Product Change Notice (PCN)

LFPCN2609001

New assembly plant for Littelfuse high voltage MOSFET in i4 package

ISOPLUS i4-Pak™ (HV) Outline

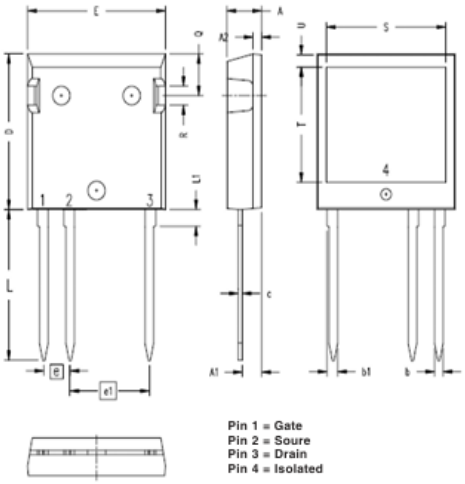
Within existing datasheet tolerances, provided below as reference.

Tube label

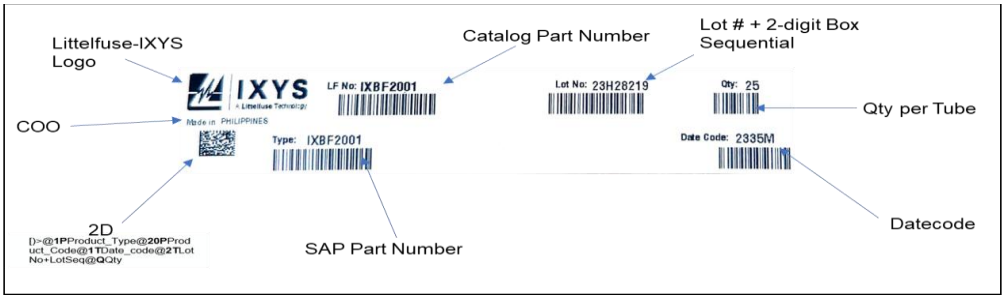
Description	Existing location	New location	Change
Unit Marking			
Logo	IXYS	IXYS A Littelfuse Technology	Y
UL Logo	No UL Logo	With UL Logo	Y
Isoplus Trademark	None	With trademark	Y
Partname	Device Name	Device Name	N
Date Code	FPMMDDYY	YYWW	Y
Assembly line code	P	M	Y
Lot #	Fab lot ID	Lipa Lot #	Y
Tube Label			
Logo	IXYS	IXYS A Littelfuse Technology	Y
Qty per tube	25	25	N
Part Number	Device Name	Device Name	N
Lot No	Fab Lot ID	Lipa Lot ID format	Y
Country of Origin	Yes	Yes	N
Code Type	Barcode	Barcode + 2D Code	Y
Date Code	None	YYWW	Y
Assembly line code	None	M	Y
Box Label			
RoHS Label			Y
Logo	IXYS	IXYS A Littelfuse Technology	Y
Qty per Box	250	250	N
Part Number	Device Name	Device Name	N
Lot No	Fab Lot ID	Lipa Lot ID format	Y
Country of Origin	Yes	Yes	N
Code Type	1DBarcode	1Barcode + 2D Code	Y
Date Code	None	YYWW	Y
Assembly line code	None	M	Y
